Access Compliance Report Public Rights-of-Way (Curb Ramps)

Main Street: SIENNA_PKWY		Cross Street: COVENANT_HILLS_DR		Location:	NW
ADA ID: RPRK220223172150	Ramp Type: Type 1 - Perpendicular	Initial Pass/Fail: Fail	Overall Compliance: No	Severity Score:	15

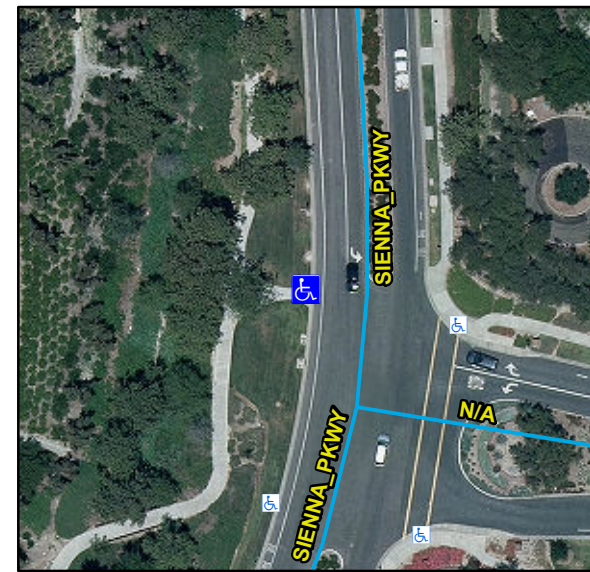
R304.2.2, STD 1115

Compliance	Description	Data	Compliance	Description	Data
N/A	Ramp Length (in)	67	N/A	Flare Type LT	
Yes	Ramp Width (in)	54			N/A
No	Ramp Run Slope (%)	8.6	N/A	Flare Slope LT (%)	N/A
Yes	Ramp Cross Slope (%)	1	N/A	Flare Traversable LT	N/A
N/A	Landing Present	N/A	N/A	Flare Type RT	
N/A	Landing Length (in)	N/A			N/A
N/A	Landing Width (in)	N/A	N/A	Flare Slope RT (%)	N/A
N/A	Landing Run Slope (%)	N/A	N/A	Flare Traversable RT	N/A
N/A	Landing Cross Slope (%)	N/A	N/A	DWS Provided	N/A
N/A	Landing Movement Obstructed?	N/A	N/A	DWS Contrast	N/A
	Landing Movement Type	N/A	N/A	DWS Length (in)	N/A
N/A	Landing Shared	N/A	N/A	DWS Full Width	N/A
N/A	Clear Space	N/A	N/A	DWS Offset Left (in)	N/A
N/A	Clear Space To Crosswalk (in)	N/A	N/A	DWS Offset Right (in)	N/A
N/A	Marked Crosswalk 1	No	N/A	Marked Crosswalk 2	N/A
	Crossing 1 Direction	E		Crossing 2 Direction	N/A
	Marked Crosswalk 1 Width (in)	N/A		Marked Crosswalk 2 Width (in)	N/A

Remove & Replace Entire Ramp.
